MEMORANDUM

Section 78 Appeal @ Former Farmstead, Big Green Farm, Ellesmere Lane, Penley, Wrexham.

Location: O. S Grid Ref: 417 396 Land South of Big Green Farm, Ellesmere Lane, Penley, Wrexham.

Development: Outline application for residential development (up to 13 dwellings) and construction of new vehicular access.

Turning Areas

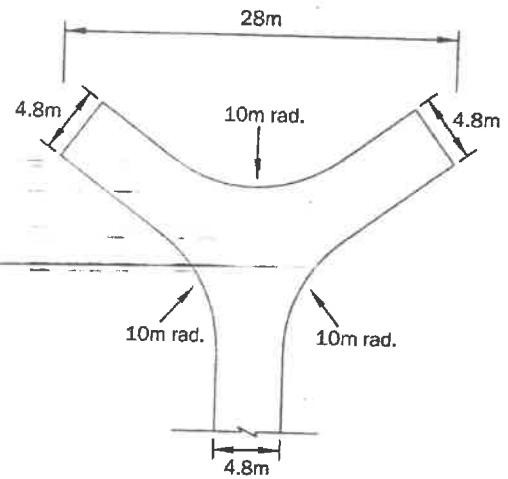
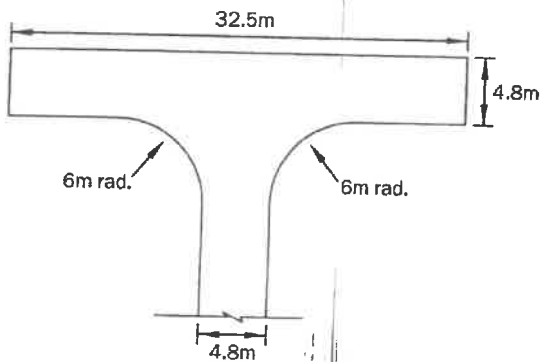
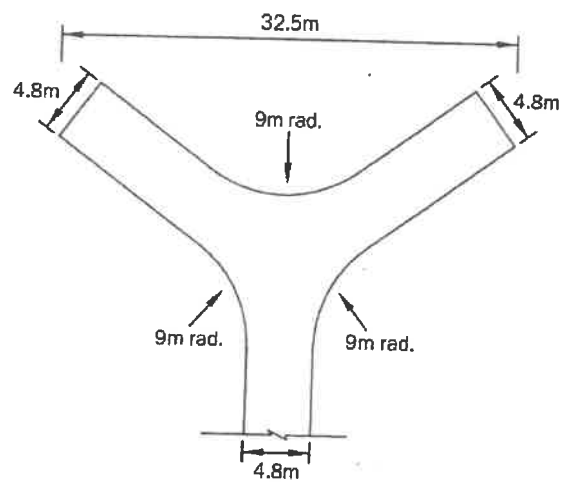
- Any proposed estate road serving up to 24 no. dwellings shall be a minimum width of 4.8m incorporating 6m kerb radii at the junction with Ellesmere Lane.
- The proposed turning head fronting plots 2- 7 will need to comply with current adoptable standards.
- The proposed turning head fronting plots 8- 11 will need to comply with current WCBC standards.
- Given the relatively remote location of the site, I would recommend maximum parking provision for each dwelling in accordance with LPGN16.
- Parking & private driveways for each dwelling shall comply with WCBC standards.

Turning areas are based on an 11.18m long, 2.55m wide refuse vehicle.
